ACRS MEETING MINUTES/SUMMARY OF THE
ADVANCED PRESSURIZED WATER REACTORS
SUBCOMMITTEE
SEPTEMBER 20, 1990
BETHESDA, MARYLAND

The purpose of this Subcommittee meeting was to review the draft SER for the W/SP-90 design. The entire meeting was open to public attendance.

Review of Westinghouse RESAR-SP-90

HOT LEG RHR CONNECTION

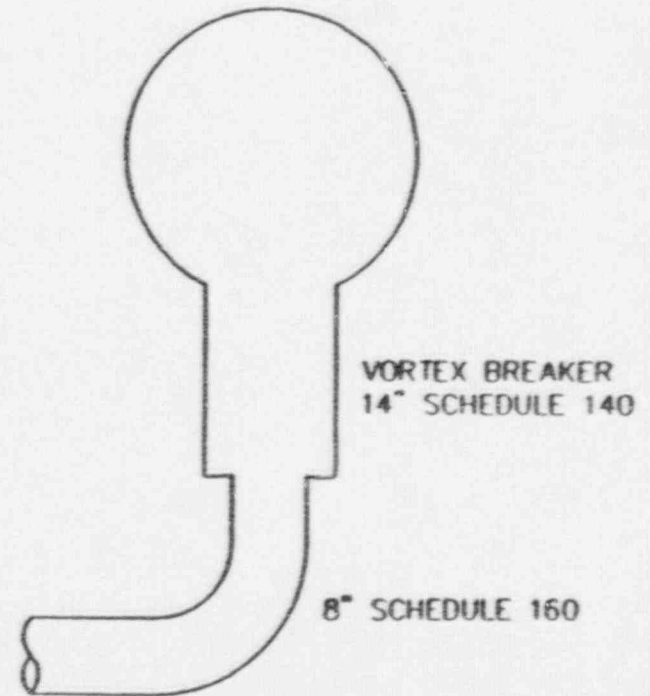
Mr. T. Van De Venne provided summary information and diagrams for Residual Heat Removal (RHR) isolation valve leak testing capabilities, and the Integrated Safeguards System. He also discussed the SP-90 design with respect to hydrogen generation and control, core-concrete interactions, high pressure core melt ejection, containment performance, equipment survivability and the OBE/SSE.

PRESENT SP/90

PDA COMMITMENT

RHR ISOLATION VALVES LEAK TESTING CAPABILITY

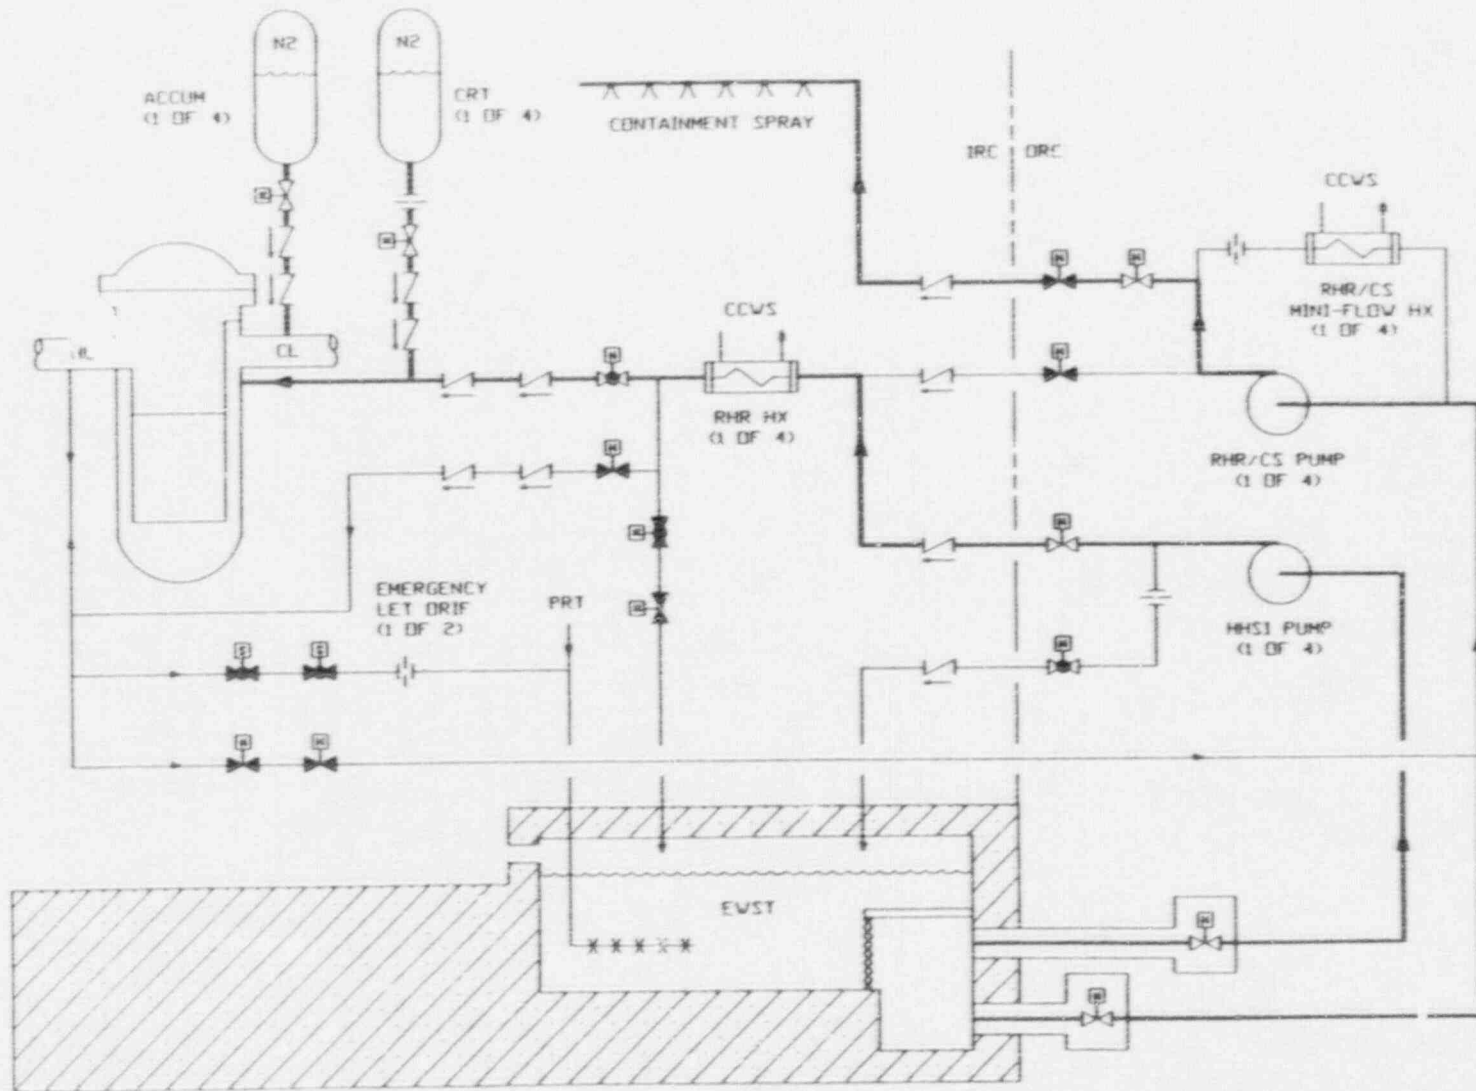
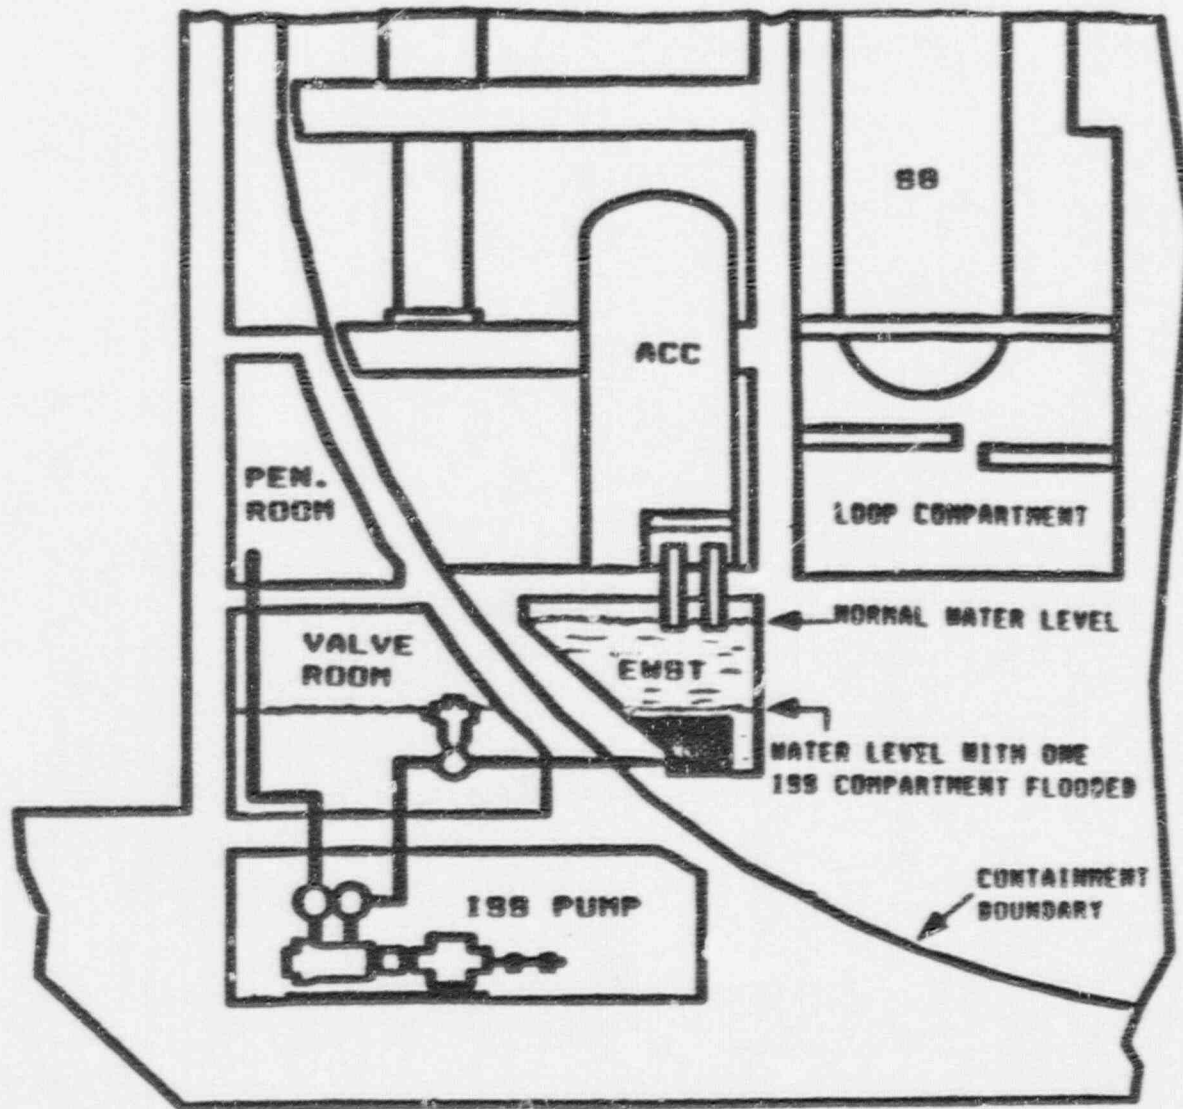
- Mr. Michelson questioned W with regard to their apparent use of a common building ventilation system. He pointed out that the staff's description of a common HVAC system for redundant trains is different than what W has presented. W stated that there are two dedicated ventilation systems per train. The reactor external ventilation system handles the ECCS pump areas below the containment sphere and isolation between trains would be provided by redundant dampers. The staff indicated that
